WSN3 - Replacing Service Cover on High-Voltage Battery E-box (Workshop Campaign)

Model Line: **Macan (XAB)**

Concerns: **Remove the service cover on the E-box.**

Installation position of service cover on E-box

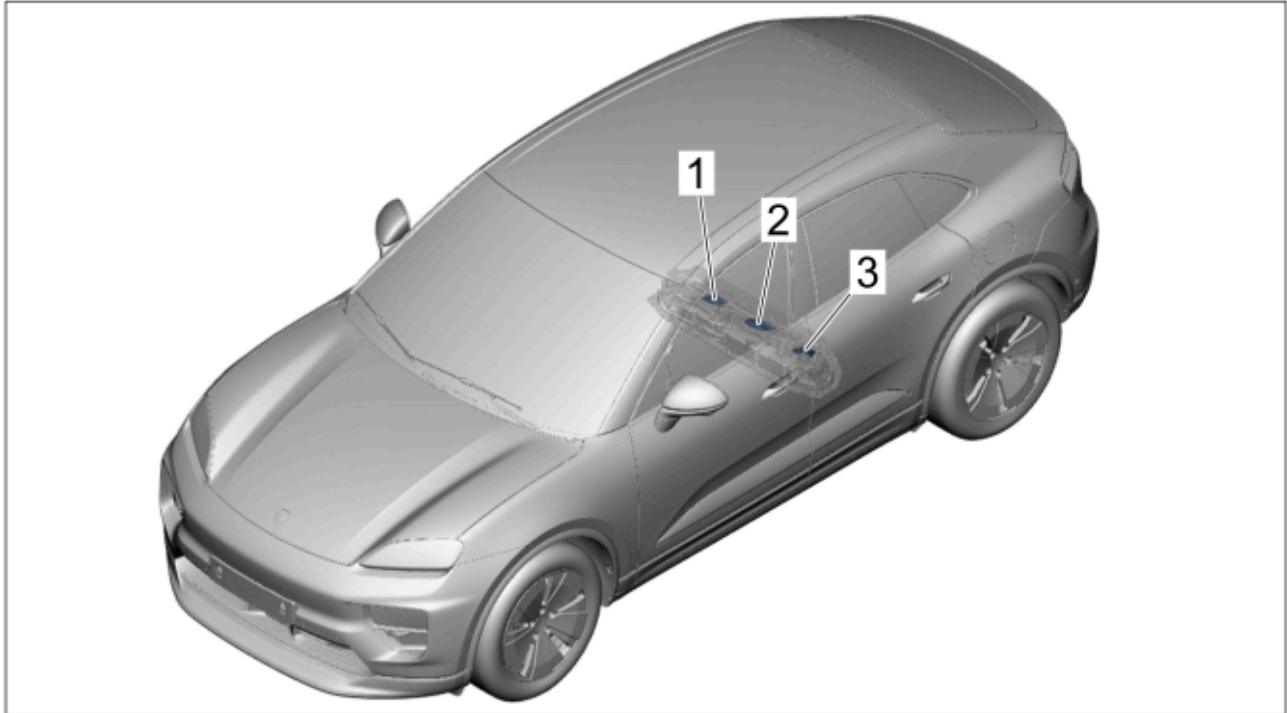
- 1 – Service cover for E-box on right (**replace**)
- 2 – Service cover for E-box in center (**replace**)
- 3 – Service cover for E-box on left (**replace**)

Service cover, right

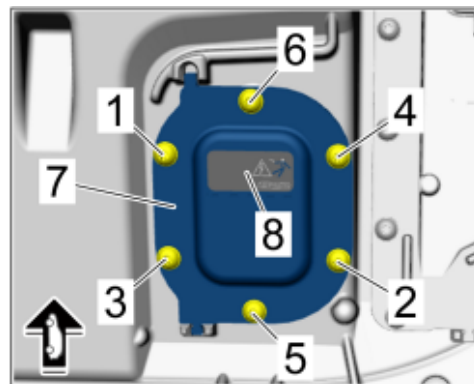
2 Replace service lid on the right ⇒ *Service cover, right -7-*.

2.1 Unscrew screws ⇒ *Service cover, right -1 to 6-* and ⇒ *Service cover, right -7-* remove **existing** service cover on the right.

2.3 Affix **new** information sign ⇒ *Service cover, right -8-* to **new** service lid on the right ⇒ *Service cover, right -7-*.

2.5 Screw in **new** screws and tighten **in sequence** ⇒ *Service cover, right -1 to 6-* with **Initial tightening 2 Nm** (1.48 ft lbs).

2.6 Tighten **new** screws **in sequence** ⇒ *Service cover, right -1 to 6-* with **Final tightening 4.5 Nm** (3.32 ft lbs).

Center service cover

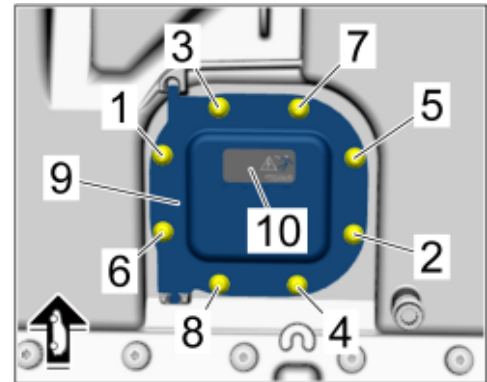
- 3 Replace center service cover ⇒ *Center service cover -9-*.

3.1 Unscrew the screws ⇒ *Center service cover -1 to 8-* and remove **existing** center service cover ⇒ *Center service cover -9-*.

3.3 Affix **new** information sign ⇒ *Center service cover -10-* to **new** center service cover ⇒ *Center service cover -9-*.

3.5 Screw in **new** screws and tighten **in sequence** ⇒ *Center service cover -1 to 8-* with **Initial tightening 2 Nm** (1.48 ft lbs).

3.6 Tighten **new** screws **in sequence** ⇒ *Center service cover -1 to 8-* with **Final tightening 4.5 Nm** (3.32 ft lbs).

Service cover on the left

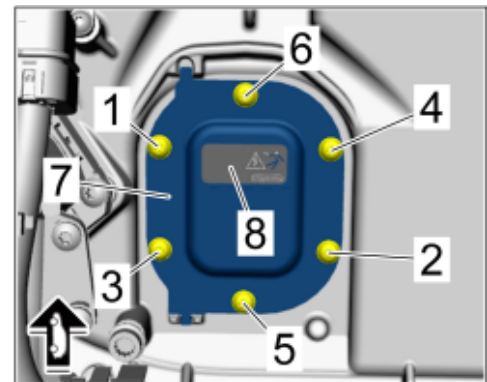
- 4 Replace ⇒ *Service cover on the left -7-* service cover on the left.

4.1 Unscrew ⇒ *Service cover on the left -1 to 6-* screws and remove **previous** service cover on the left ⇒ *Service cover on the left -7-*.

4.3 Affix **new** information sign ⇒ *Service cover on the left -8-* to **new** service cover on the left ⇒ *Service cover on the left -7-*.

4.5 Screw in **new** screws and tighten **in sequence** ⇒ *Service cover on the left -1 to 6-* with **Initial tightening 2 Nm** (1.48 ft lbs).

4.6 Tighten **new** screws **in sequence** ⇒ *Service cover on the left -1 to 6-* with **Final tightening 4.5 Nm** (3.32 ft lbs).
